PHAP26-00002

Date: February 19, 2026
Application Type: Certificate of Appropriateness
Property Owner: Christine Ververis
Representative: HMR Windows
Legal Description: 19 Sunset Heights E 60 Ft Of 35 To 40 (9000.00 Sq Ft), City of El Paso, El Paso County, Texas
Historic District: Sunset Heights
Location: 1111 W. Yandell Drive
Representative District: #8
Existing Zoning: R-4/H (Residential/Historic)
Year Built: 1907
Historic Status: Landmark
Request: Certificate of Appropriateness for window installation
Orig. Application Filed: 2/5/2026
Orig. 45 Day Expiration: 3/22/2026

ITEM #1

Certificate of Appropriateness for window installation

PROPOSED WINDOW

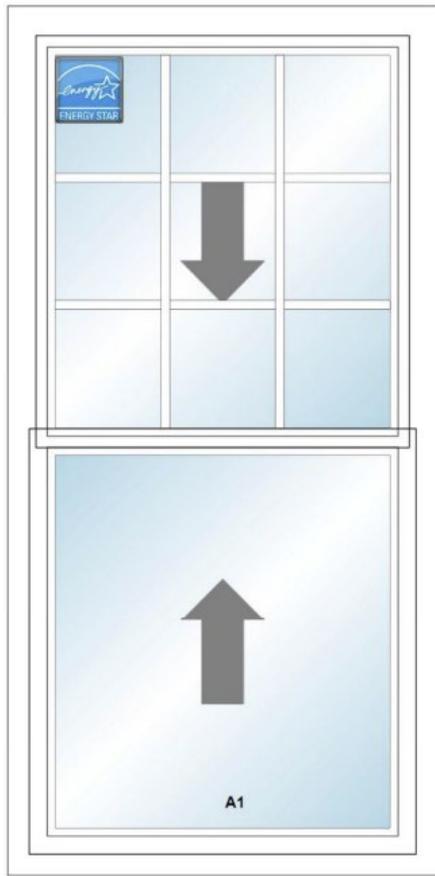
The modification is that windows be muntins be exterior applied and three-dimensional.
